BELLOWS ADDITION

WICHITA, SEDGWICK COUNTY, KANSAS

RE: SUB 2000-51 -- One-Step Final Plat of BELLOWS ADDITION

At the regular meeting of the Subdivision Committee of the Metropolitan Area Planning Commission on Thursday, July 6, 2000, the above captioned plat was considered. The action of the Committee was to approve the final plat, subject to:

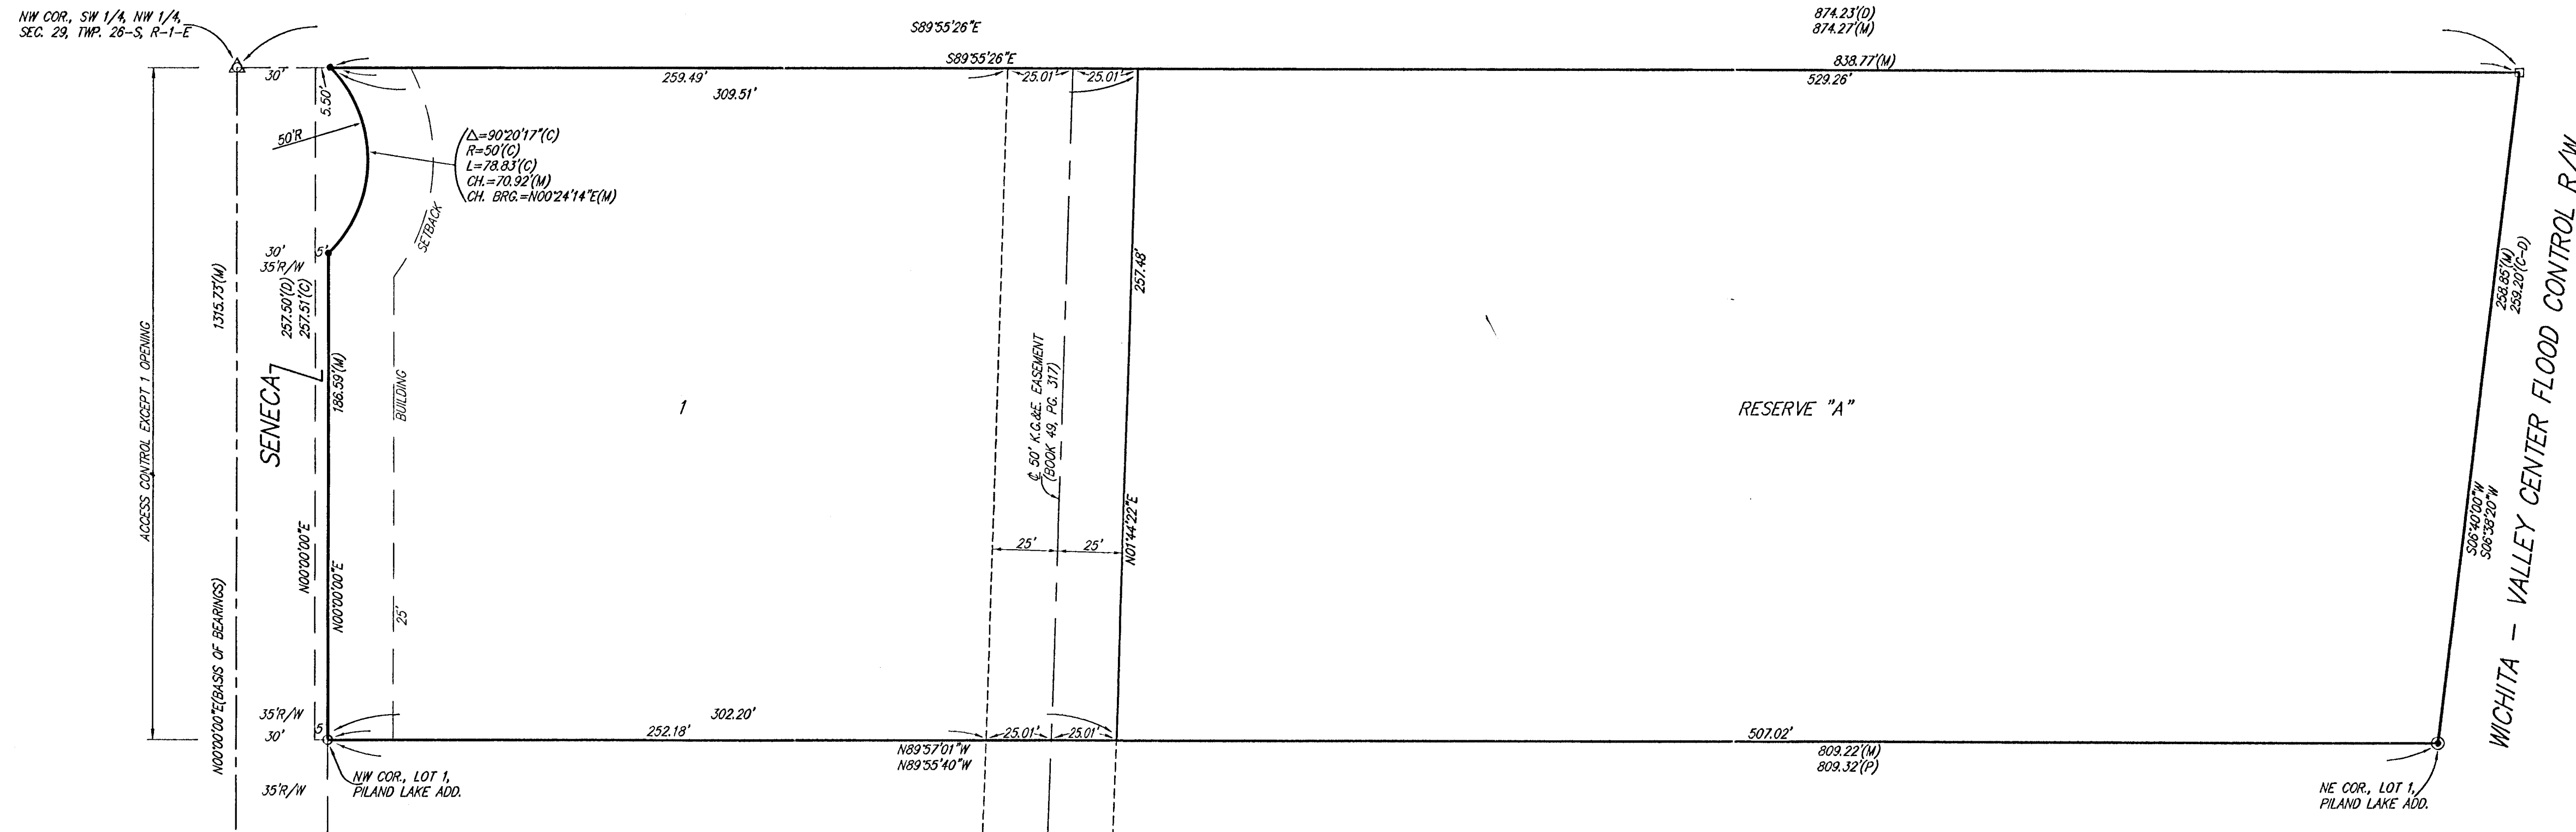
- D. City Engineering needs to comment on the status of the applicant's drainage plan and the need for the platting of a Floodway Reserve for the existing lake. A Floodway Reserve should be platted for the eastern portion of the property.

- E. Traffic Engineering needs to comment on the need for access controls. The final plat tracing shall reference the access controls in the plat's text. Traffic Engineering has approved access control except for one opening along Seneca.

- G. Due to the excessive lot depth, City Fire Department needs to comment on the need for a maximum building setback to accommodate fire prevention equipment. The plat shall include a Floodway Reserve along the eastern portion which would limit construction.

- H. The lot depth to width ratio exceeds 2.5 to 1 and a modification from the Subdivision Committee will be required. A modification is approved.
- I. The 50-foot KG&E easement needs sufficient ties to locate it definitely with respect to the subdivision.

- J. The plat's text shall include language that a drainage plan has been developed for the plat and that all drainage easements, rights-of-way, or reserves shall remain at established grades or as modified with the approval of the applicable City or County Engineer, and unobstructed to allow for the conveyance of stormwater.
